# **Final Safety Evaluation Report** on the Construction Authorization Request for the Mixed Oxide Fuel Fabrication Facility at the Savannah River Site, South Carolina

Docket No. 70-3098

Duke Cogema Stone & Webster, L.L.C.

**U.S. Nuclear Regulatory Commission**  
**Office of Nuclear Material Safety and Safeguards**  
Washington, DC 20555-0001

**Figure 8.1-2 Empirical venting relationship**

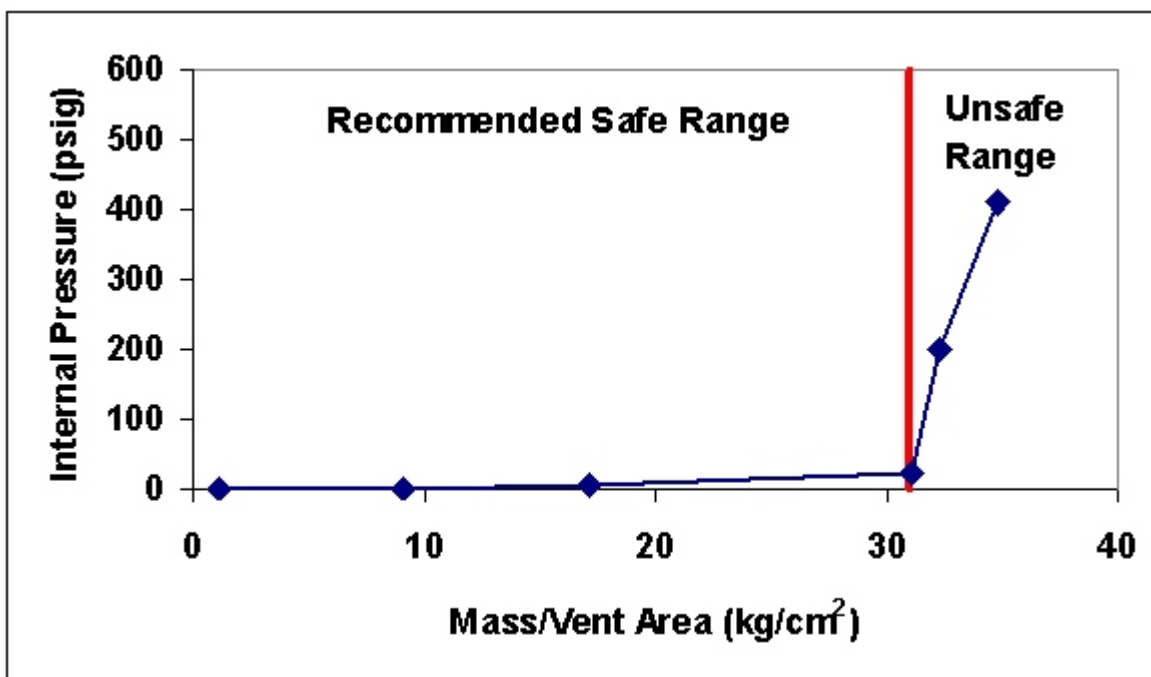
The derived venting relationship is shown as Figure 8.1-2 and relates vent cross-sectional area to the mass of organic material present and the internal pressure generated from the red oil reactions. The recommended safe range is below a value of 32 kg organic compounds/cm<sup>2</sup> of vent area, which essentially prevents pressurization of the vessel containing the red oil/nitric acid mixture. For comparison, the applicant's design basis for the offgas treatment system in open systems is 12.5 kg/cm<sup>2</sup> (0.008 mm<sup>2</sup>/g) of organic material present in the vessel. This compares to a 32-kg/cm<sup>2</sup> limit for rapid pressurization, as shown in Figure 8.1-2. Thus, the applicant's design basis for open systems is in the recommended safe range and provides for a safety margin of about 60 percent below the initiation conditions.

- Tanks in which TBP-nitrate complexes are or may be present should be adequately vented. A value of 0.032 cm<sup>2</sup>/kg (0.005 in.<sup>2</sup>/kg or 31 kg/cm<sup>2</sup>) of TBP is mentioned. This is based upon Figure 8.1-2.
